144 DC - Duncans Creek Rd., Lillington, NC 27546

# PLAN 6

## The Raleigh - LH

**1-26-24 - Initial Redlines - JJ**

**SUPER SHOWER SLAB FND OPTION**  
 SCALE: 1/8"=1'-0" ON 11x17, 1/4"=1'-0" ON 22x34

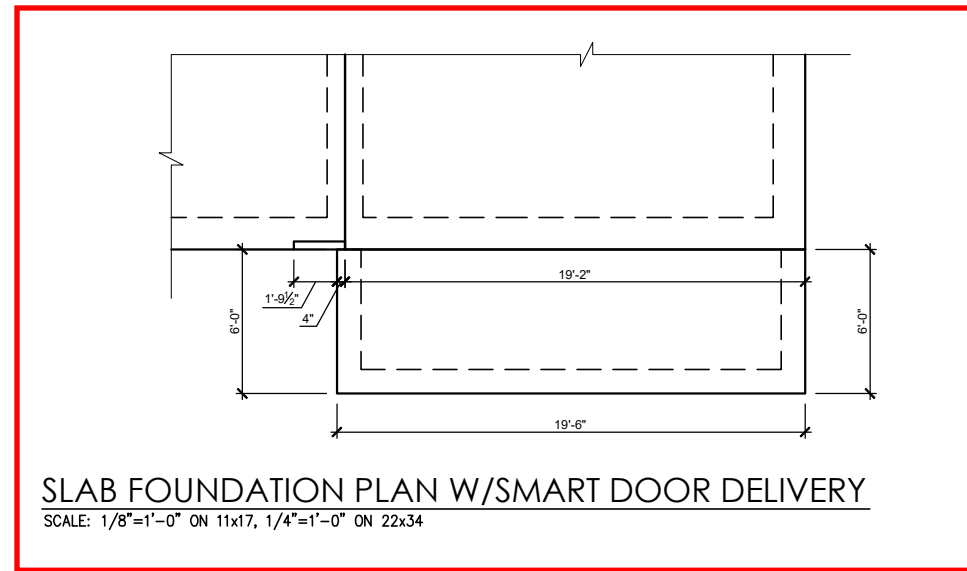
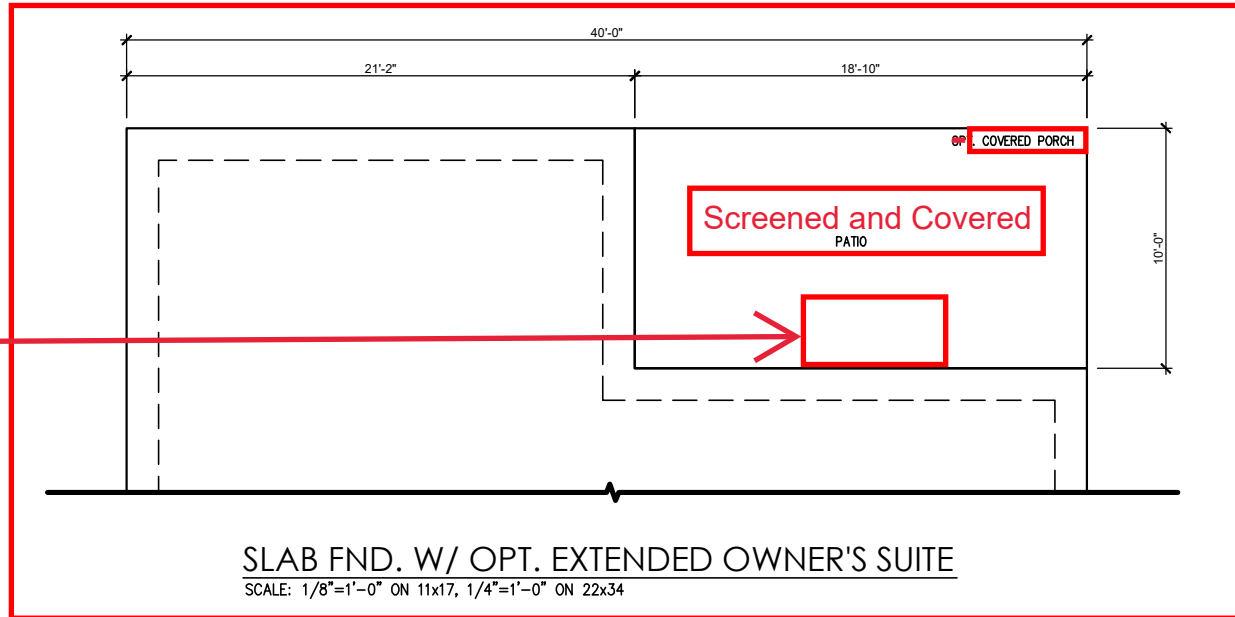
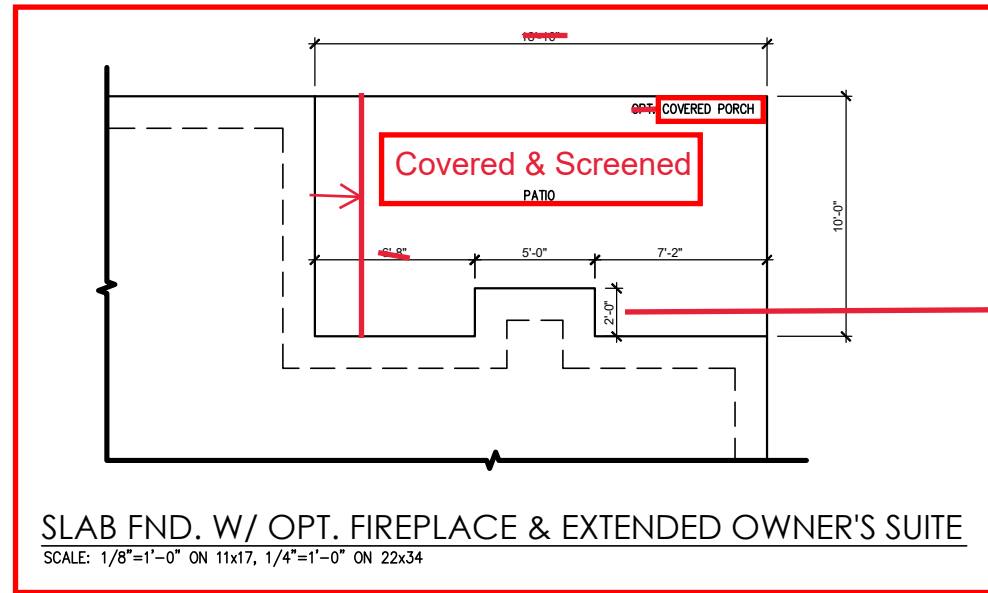
See Sheet 1.1.2d for third car garage

See Sheet 1.1.1d for smart door delivery

See Sheet 1.1.1d for fireplace and extended owner's suite foundation

SHEET  
**2.1d**

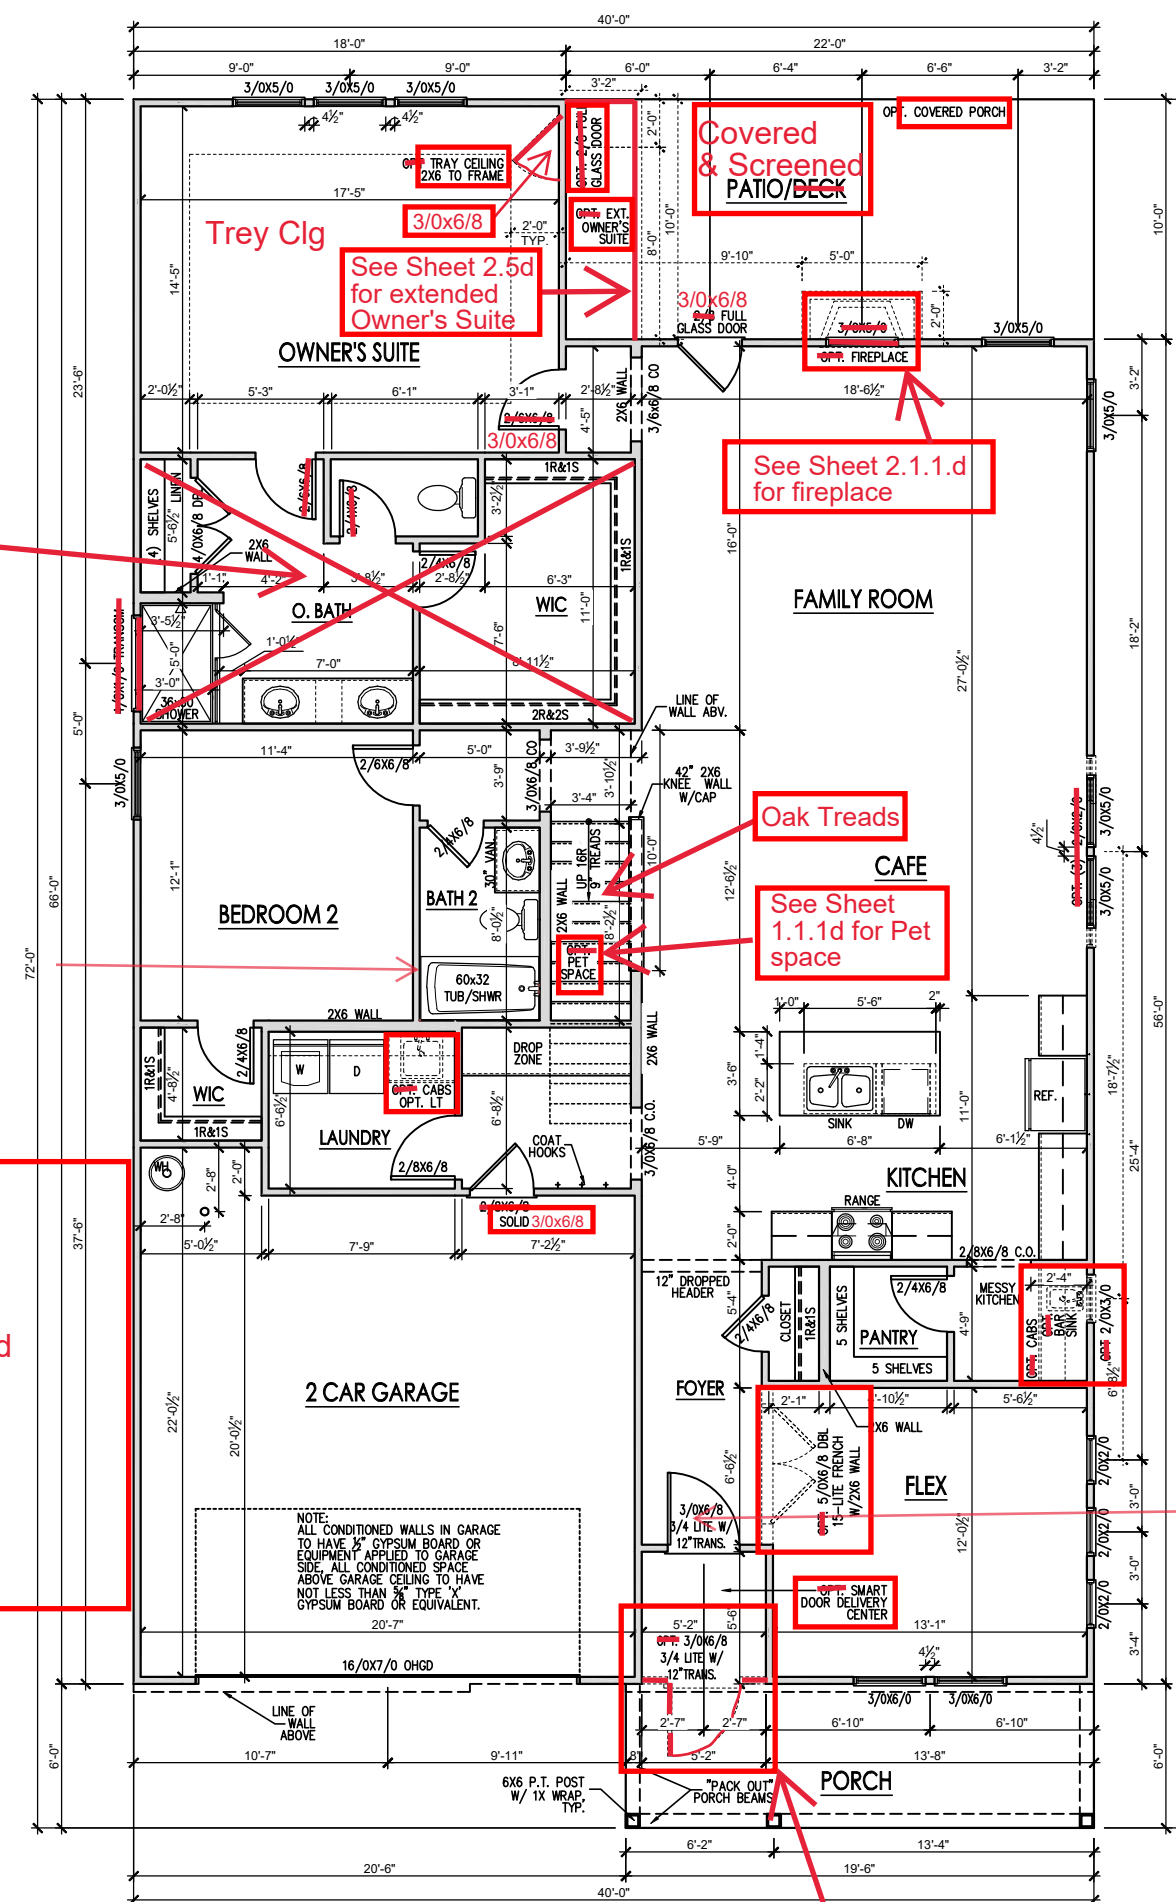
See Sheet 2.1.1d for Super Shower door sizes and new dimensions for closet and water closet

Center of door from corner to be 3'-7 1/2"

3'x3' pad  
3/0x6/8 door  
See sheet 2.8d for third car garage

See Sheet 1.1.1.d for Pet space

See Sheet 2.2.1d for Smart Door Delivery

SHEET  
**2.2d**

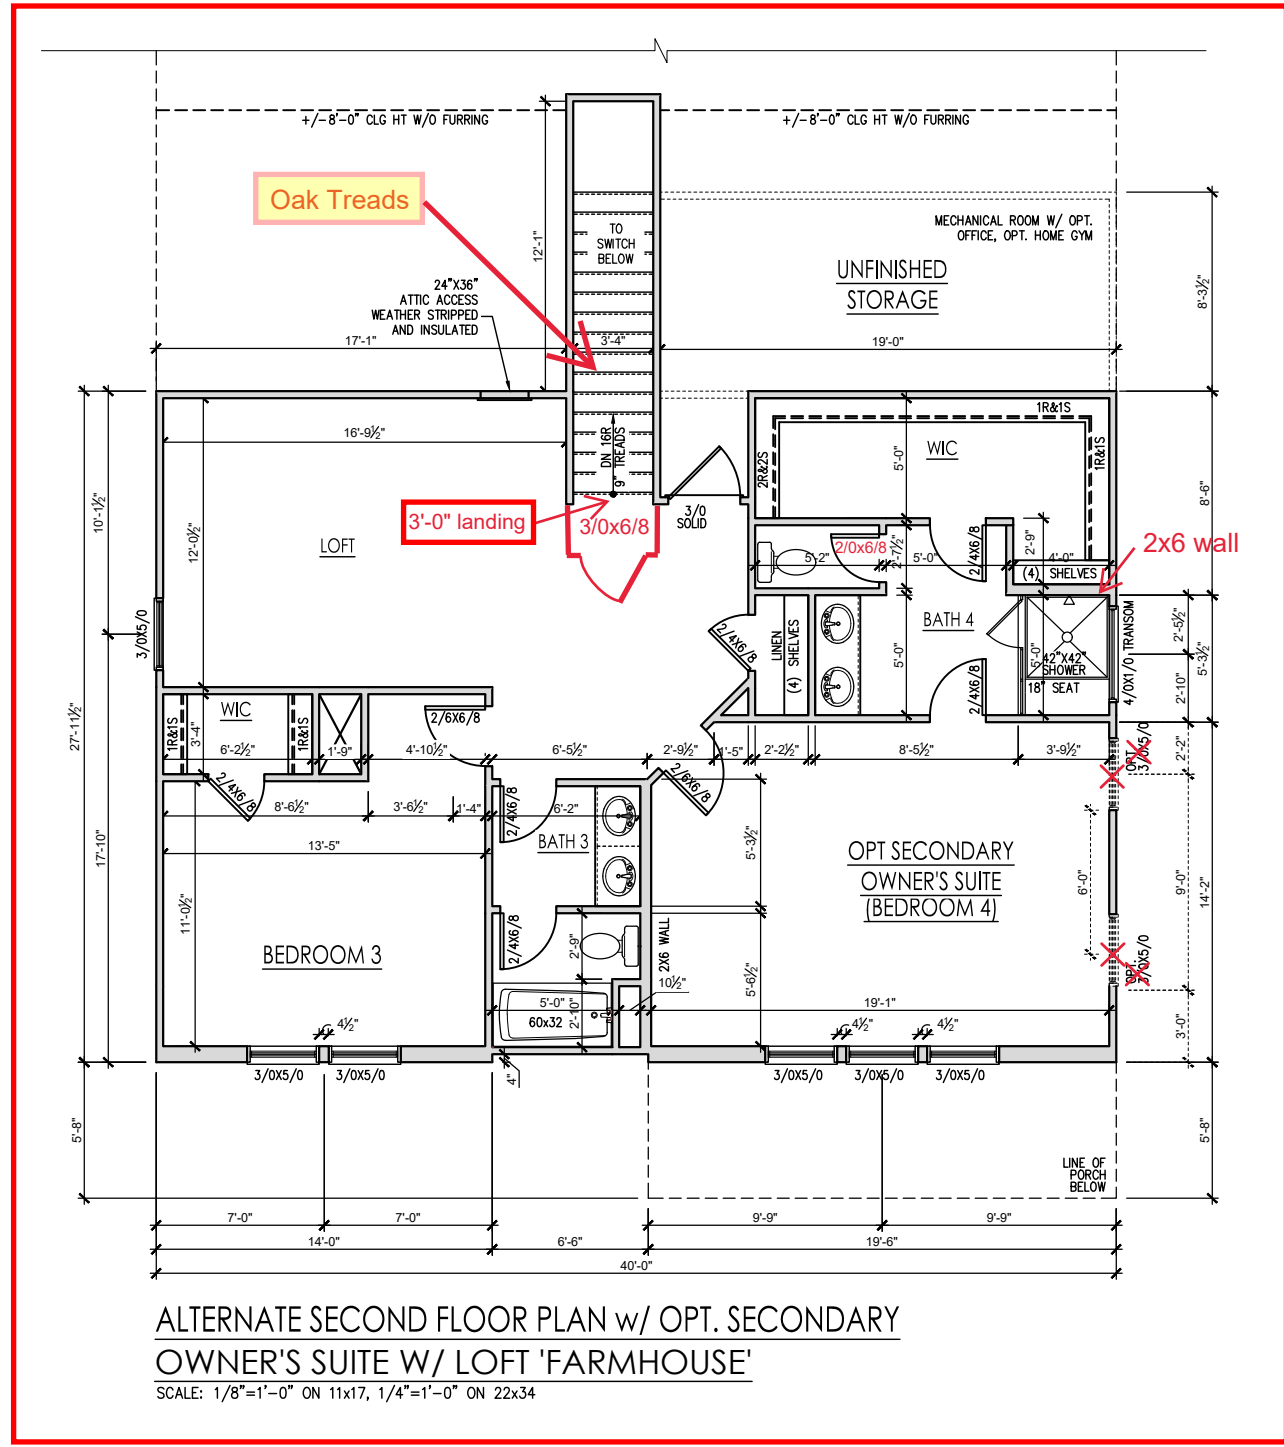
See Sheet 2.2.d for loft, landing and door at the top of the stairs, entry into bedroom 3

See Sheet 2.2.d for bedroom and bathroom

**FIRST FLOOR FLOORING PLAN 'FARMHOUSE'**  
SCALE: 1/8"=1'-0" ON 11x17, 1/4"=1'-0" ON 22x34

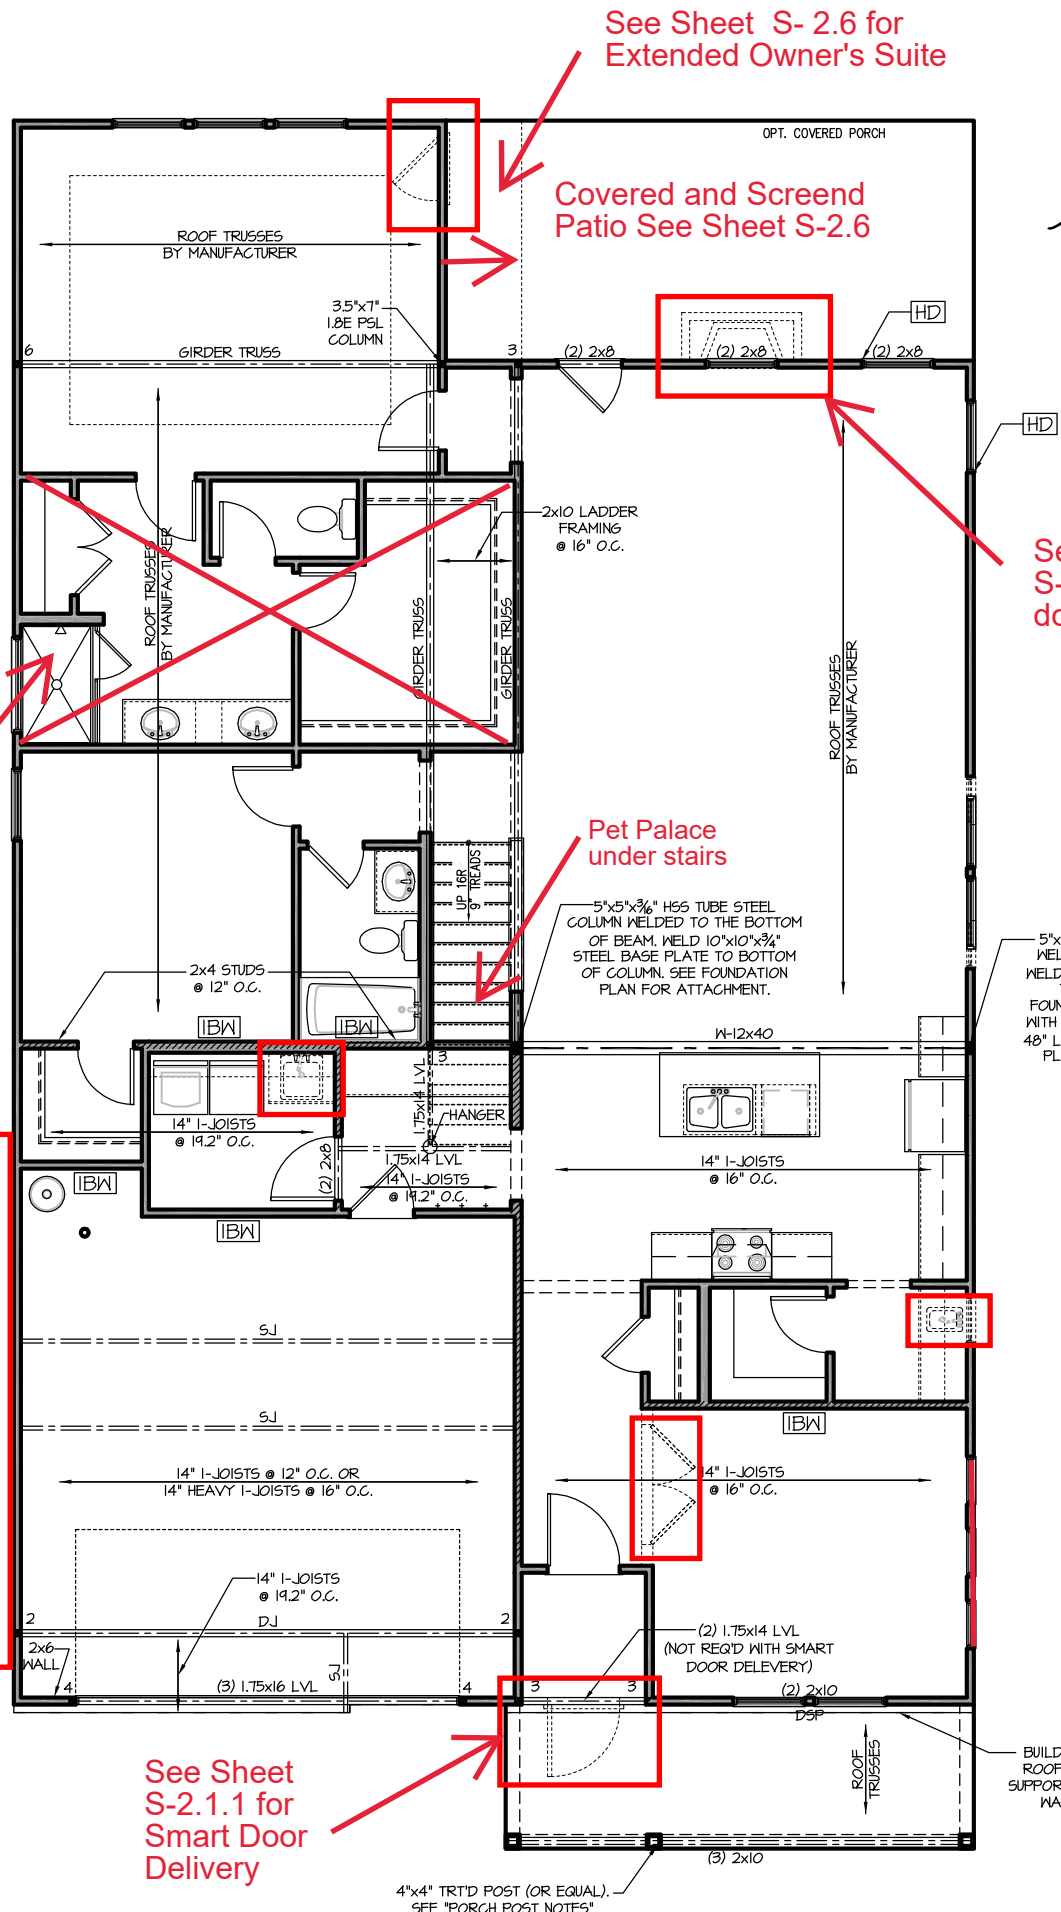
See Sheet S-2.6 for Extended Owner's Suite

Covered and Screened Patio See Sheet S-2.6

See Sheet S-2.1.1. for fireplace

See Sheet S=2.1.1 for Owner's Shower

See Sheet S-2.1.2 for Third Car Garage

See Sheet S-2.1.1 for Smart Door Delivery

**SECOND FLOOR FLOORING PLAN 'FARMHOUSE'**  
SCALE: 1/8"=1'-0" ON 11x17, 1/4"=1'-0" ON 22x34

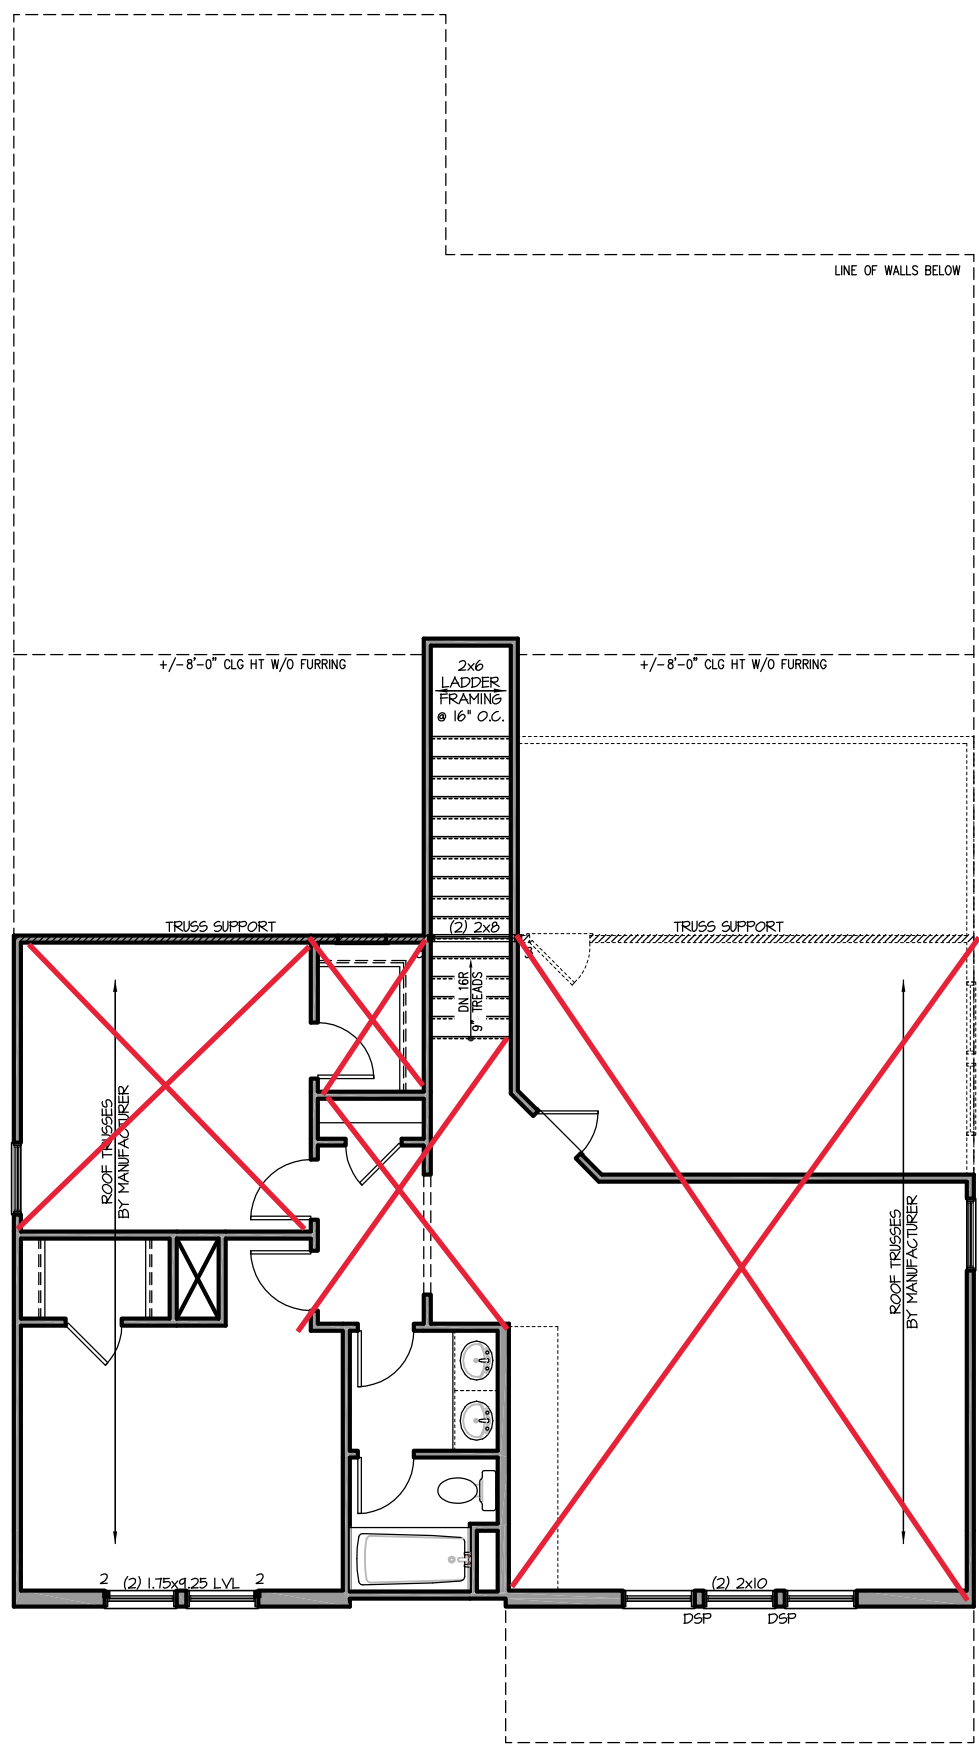
See Sheet S-2.2.2 for correct second floor layout
